Urgent Field Safety Notice

GE Healthcare Ref: FMI 80128

RE: **Advantage Workstation: AdvantageSim – Inconsistent DRR (Digitally Reconstructed Radiographic) Visualization**

Illustration 2: Obvious misaligned blended DRR using the **Center on Cursor** feature

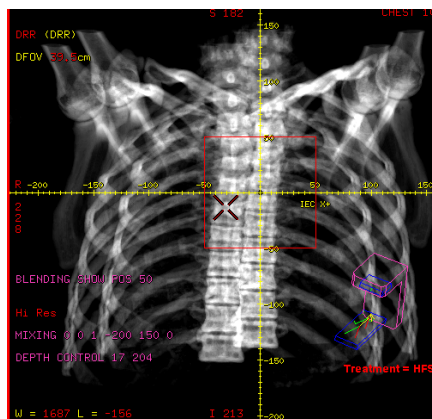
1. When using the **Center on Cursor** feature in combination with a blended DRR in certain AdvantageSim versions, the captured DRR will remain fixed in the original position while the active DRR will move to a position where the 3D cursor is centered on the screen.

Lung DRR with airway pulled out and blended. After **Center on Cursor**, location of the misaligned carina below the cross-hairs.

The blended DRR can be re-aligned to show both DRRs in the correct position by switching the DRR off/on once using the leftmost button of the beam toolbar (see below).

Illustration 5: Blended DRR before (left side) and after (right side) **Isocenter Move** mode (green highlighted button) is used to change isocenter. The example represents an extreme isocenter movement to illustrate the effect.

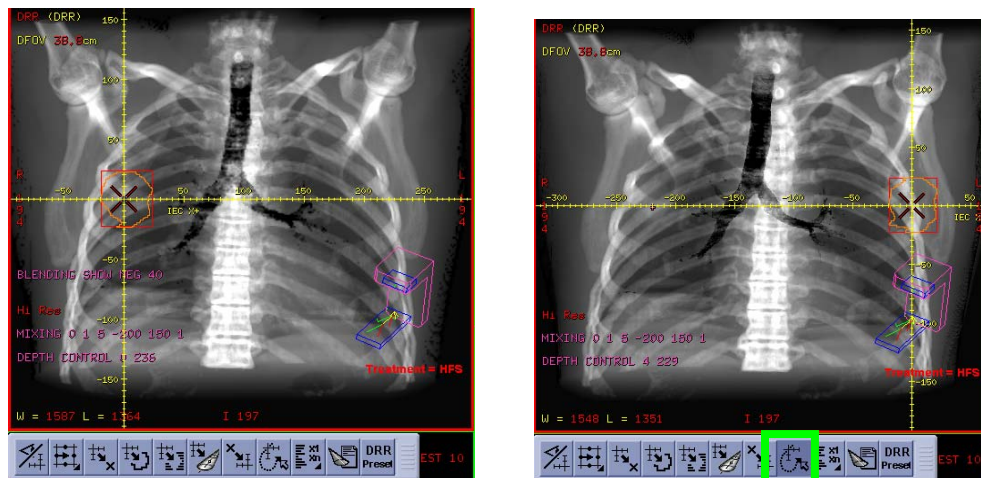
- When using the **Isocenter Move** mode feature in combination with a blended DRR in certain AdvantageSim versions, the captured DRR will remain fixed in the original position while the active DRR is correctly recalculated and shown.

The blended DRR can be re-aligned to show both DRRs in the correct position by switching the DRR off/on once using the leftmost button of the beam toolbar (see below).

Illustration 6: 0% phase blended with 0%phase (left side) and 50% phase blended with 0%phase (right side). Both show 0% phase in upper left corner

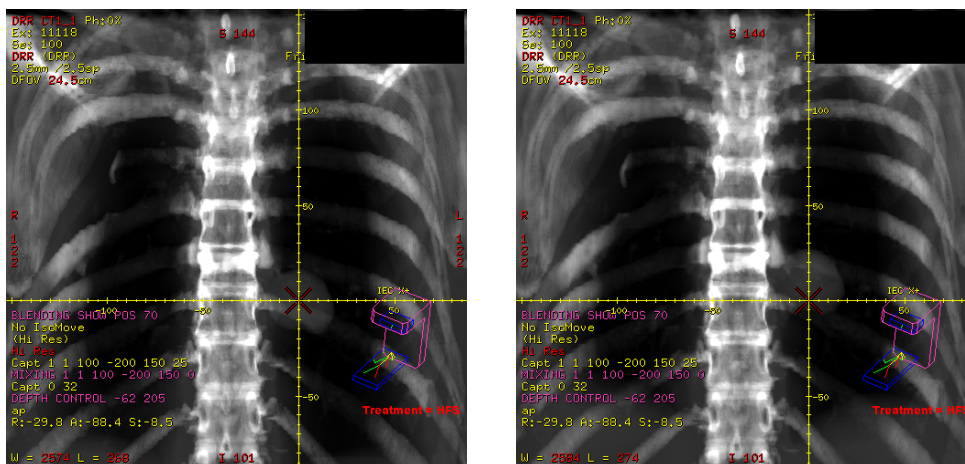
- When the image series is changed (on the top left corner of a DRR view) while using DRR blending, the captured DRR is not recalculated or cancelled.

The blended DRR can be re-aligned to show both DRRs in the correct position by switching the DRR off/on once using the leftmost button of the beam toolbar (see below).

Illustration 7: Initial DRR with bone preset (left side), Incorrect visualization after blending with a different preset (right side)

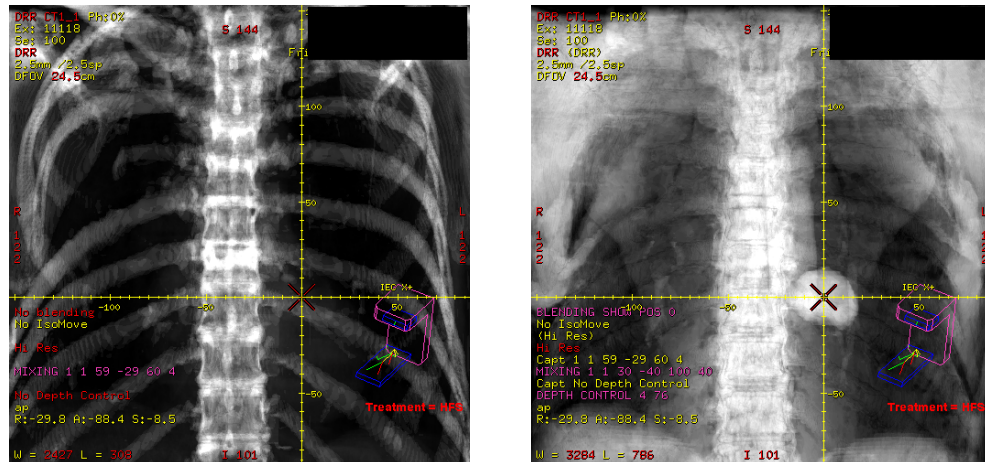
4. When using the blended DRR function the visualization of the captured DRR may change without the visualization parameters (MIXING and DEPTH CONTROL) being updated on-screen after choosing a DRR preset for the active DRR.

In order to properly visualize the DRR, it is important that a preset is not used for the 2nd DRR of the blended pair. If the issue has already occurred, follow the sequence below to restore correct visualization:

1. Turn off blending
2. Select a preset for the 1st DRR
3. Capture DRR
4. Manually apply mixing and/or blending
5. Turn blending on

Illustration 8: Initial Blended DRR with all annotation shown (left side), after adding another beam blended annotation is not shown (right side)

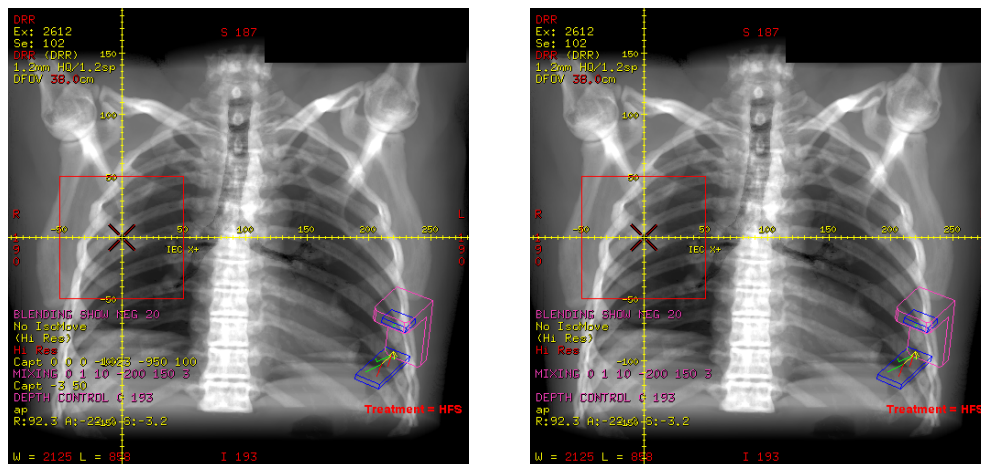
- When a new beam is created after using DRR blending on a previous beam, switching back to the previous beam may cause annotations for BLENDING, MIXING and DEPTH CONTROL to not be shown.

The annotation can be restored by switching the DRR off/on once using the leftmost button of the beam toolbar (see below).
